"Preliminary, Do not fabricate"

LAFAYETTE

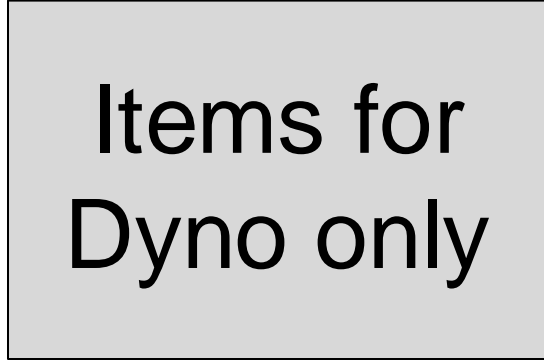
This cable might need more connections TSI needs to decide. Suggestion, bring all pots back

Connect to TSI where packs are during Dyno room testing before the packs are ready
